Product Change Notification

111975 - 00

Change Notification #: 111975 - 00
Change Title: Local Control Panel (LCP) Accessory
AXLCPRACK2
PCN 111975-00, Product Design
Change A Resistor for the Front Panel LED
Date of Publication: December 19, 2012

Below is a picture of the LCP side to show the serial number location:

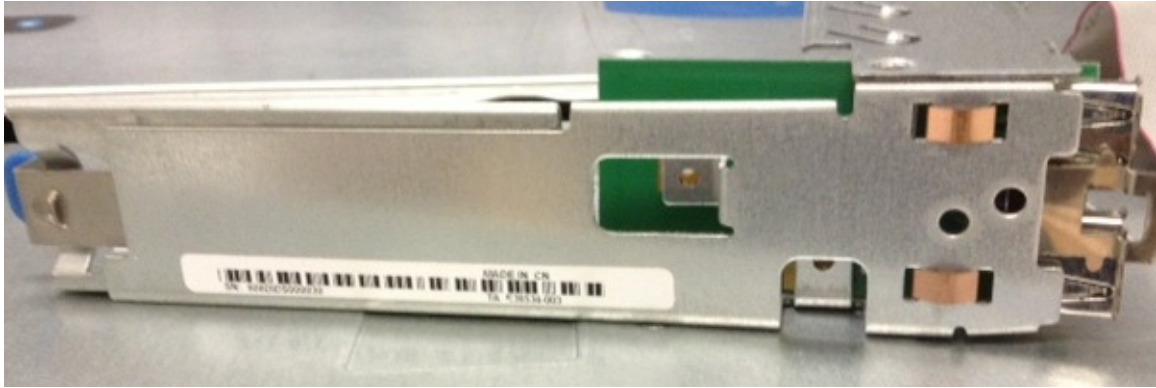
A resistor will be changed for the AXLCPRACK2 front panel LED. The system status LED resistor "R6" will be changed from a 402 ohm to a 1.5 ohm. This change corrects an issue where the system status LED glows dim amber when it should be off. This issue could be seen while the system was in stand-by mode. Another side effect this change corrects was a yellow discoloring of the green system status LED.

The LCP with pack date after October 2012 (see box label below) or with serial number starting with SN#248DIDS000001 on the side of LCP unit (see picture of the LCP below) will have the updated resistor.
